Bulletin No. 2002-10

Fusible Link V-6 Charging System

2003 V-6 EFI/OptiMax
S/N 0T599000 and Above

59364

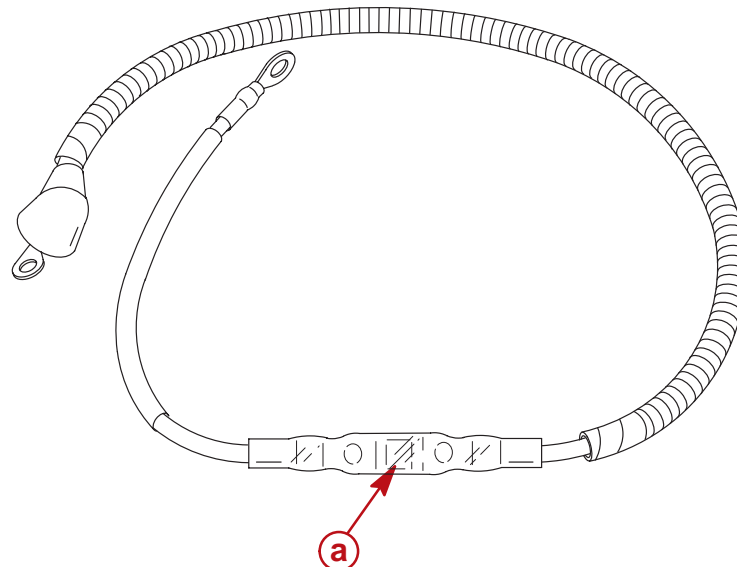
The 2003 model year V-6 outboards (EFI/Optimax) that use a belt driven alternator will have a 100 ampere fusible link between the alternator and the slave solenoid. This fusible link is designed to protect the alternator from damage due to accidental reverse battery connection. If the battery cables are reversed, the fusible link will create an open circuit and must be replaced. With the fusible link open, the engine can be started but the run time will be limited because the alternator is not charging the boat battery. The fusible link is part of the wire assembly. If the fusible link circuit becomes open the fuse and wire must be replaced as an assembly.

The fusible link (**P/N 84-878231A6**) is a new product feature for the 2003 model year. This bulletin is to inform you of its presence in advance of pending service manual updates.
